Why Caltrans Should Adopt the New National Standard for Bicycle Railing Height

Vince Taylor

Excerpts from and Comments on "Determination Of Appropriate Railing Heights For Bicyclists," NCHRP Report Project 20-7 (168)

Figure 7
Center of Gravity

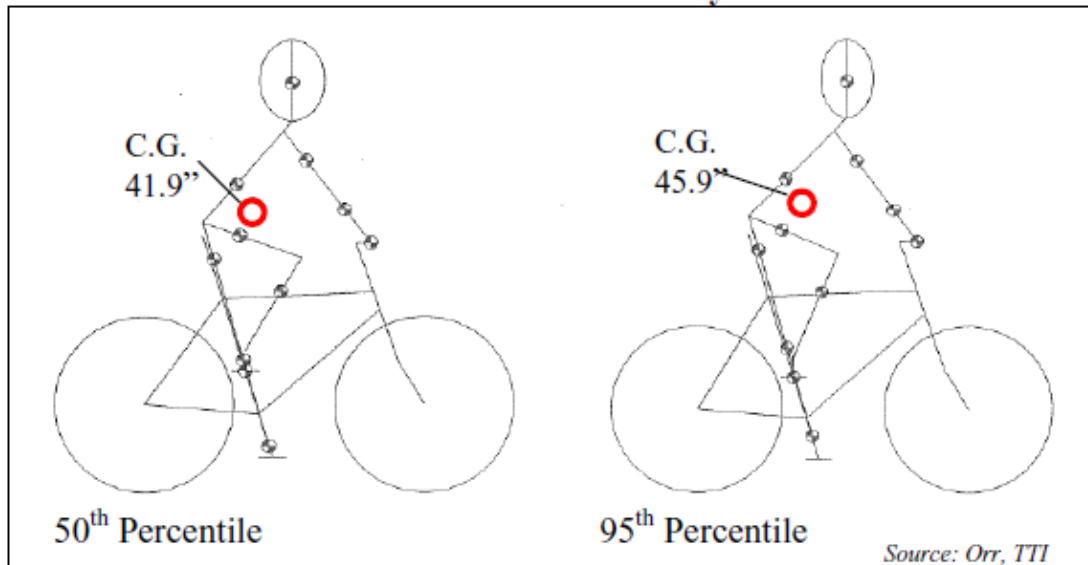
The report discusses important limitations of the above engineering analysis. In particular, it notes that AASHTO requires guard rails for vehicles be only 27" in height, deeming this sufficient to prevent even large vehicles and trucks from vaulting over the barrier. The reasoning behind this is that there will generally be insufficient inward (toward the railing) velocity to rotate the vehicle mass over the seemingly low barrier.

The same considerations apply in determining the safe heights for bicycle railings. As a cyclist will normally encounter a guard rail when he or she swerves off course, the velocity into the rail will generally be quite minimal and insufficient to lift the cyclist over a rail considerably lower than his or her center of gravity.⁴

Orr's findings are based on the simple theory that the bicyclist's COG must be below the height of the railing to prevent a bicyclist from falling over the railing. This theory does not take into account any of the other dynamics of a collision with a railing. For example, when a bicyclist is traveling parallel with a railing, a lateral force must be from a redirection of the bicyclist's momentum due to loss of control of the bicycle or a collision with an object prior to the collision with the railing. The lateral force of the collision with a railing is directly related to the sideways momentum of the bicyclist or the angle of the collision with the railing.

As the COG represents the center of a much larger mass, the point of contact of the body with the railing would not likely occur at the COG, but at a distance equal to approximately one-half the width of the body away from the COG. The lateral force applied to the body must be adequate to rotate the COG over and around the point of contact. Therefore, it is possible that a railing lower than the

height of the bicyclist’s COG would prevent the bicyclist from falling over the railing. This is the same phenomenon that often prevents a large vehicle or truck from vaulting over a 0.7-meter (27-inch) high railing during a crash event. A simulation or modeling of the lateral force necessary to vault a bicyclist over a railing lower than the bicyclist’s COG would be difficult to accomplish without crash testing to verify or calibrate the assumptions and variables. (Pages 15, 16, emphasis added.)

Figure 9 - Preferred Railing Height of Advocacy Groups

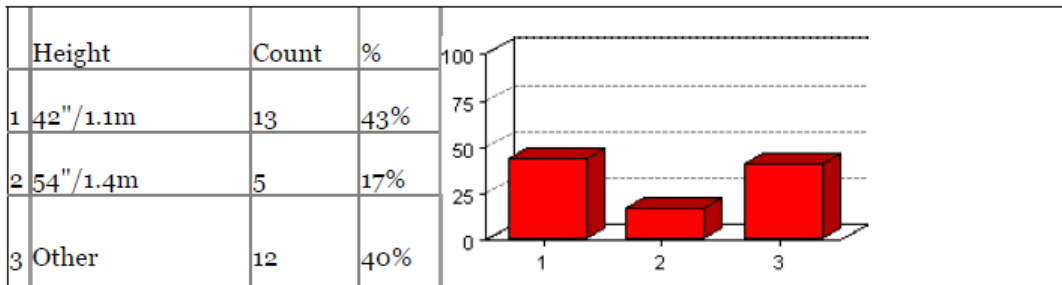
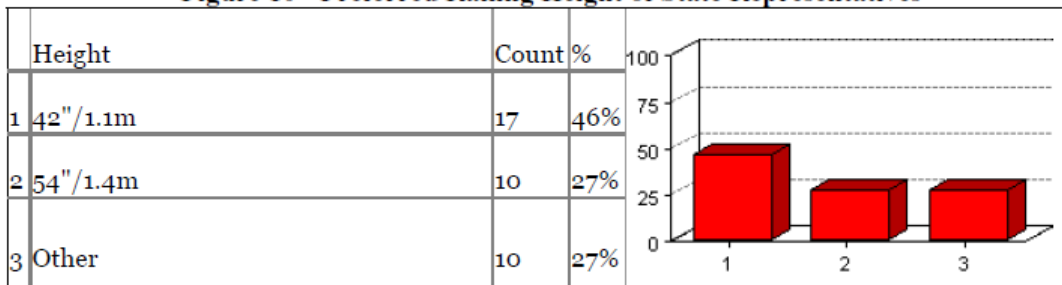
In the charts, the first column measures those who unqualifiedly preferred 42" railings and the second, 54" railings. The third column were those who had more complex responses. A review of the more complex answers indicates that a high proportion prefer 42" except for specially hazardous situations, e.g., very long bridges, very windy conditions.

Among bicycle advocates, 78% of unqualified responses favored 42" railings. Among state planners, 63% unqualified responses favored 42" railings
